DATE: January 12, 2017
TO: BLUE BIRD OWNERS
SUBJECT: RECALL R16YL
VISION STARTER CABLE ROUTING W/CAT C707 ENGINES

NHTSA Recall Number: 16V-100 School Bus
NHTSA Recall Number: 16V-101 Non-School Bus

Vision Starter Cable Routing

Models Affected: 2008-2009 BBCV Visions with Caterpillar C707 Engines

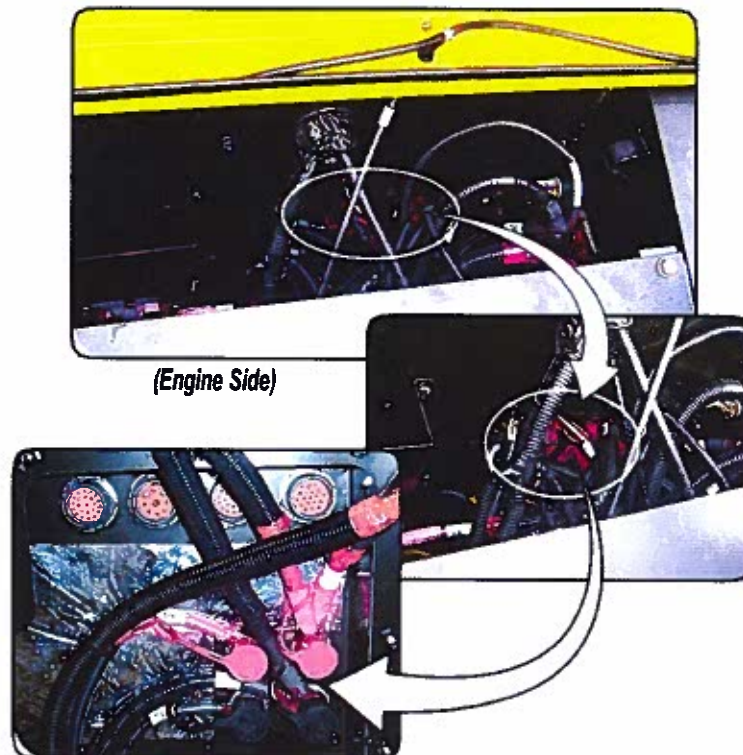
Starter cable may have been installed on the incorrect power stud which could cause the 4 gauge cable to be compromised during cranking process.

If starter cable is installed incorrectly, relocate starter cable from Electrical Power Stud to Chassis Power Stud. Inspect 4 gauge battery cable from Electrical Power Stud to battery for any damage and replace any damaged cable.

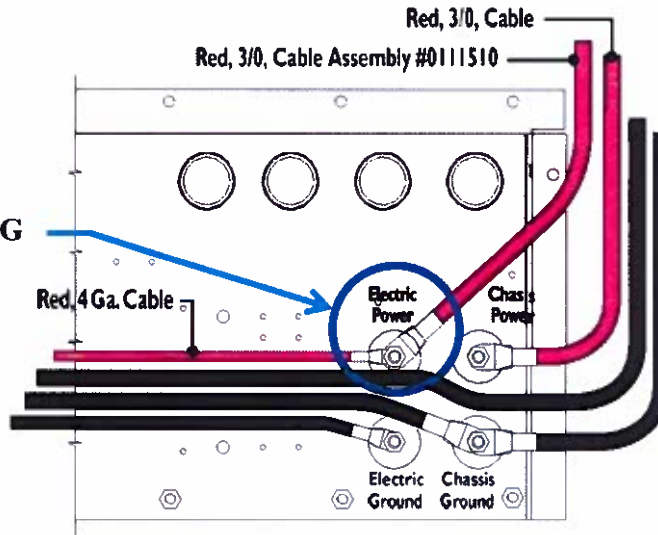
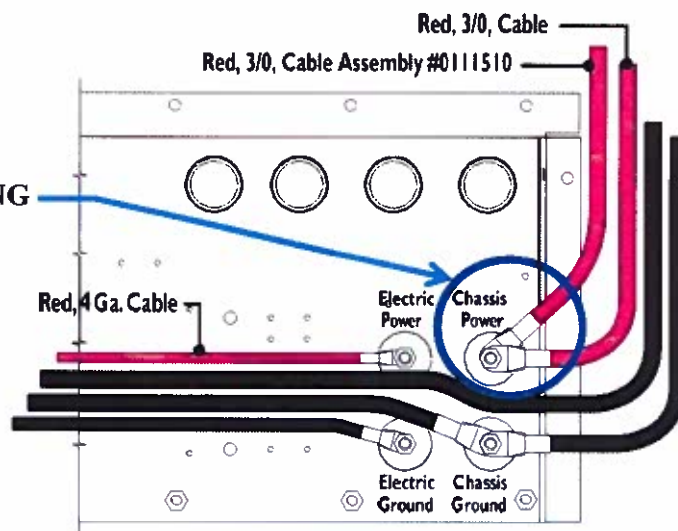
4. The lower end of Cable Assembly 0111510 should be attached to the Chassis Power Stud. If the cable is in this location, no further action required. If the lower cable end is attached to the Electrical Power Stud, remove it and attach it to the Chassis Power Stud. (See figures below)
5. Tighten both stud nuts to 11-15 ft.lbs. and apply a corrosion protection such as red glyptal.

INCORRECT ROUTING

CORRECT ROUTING
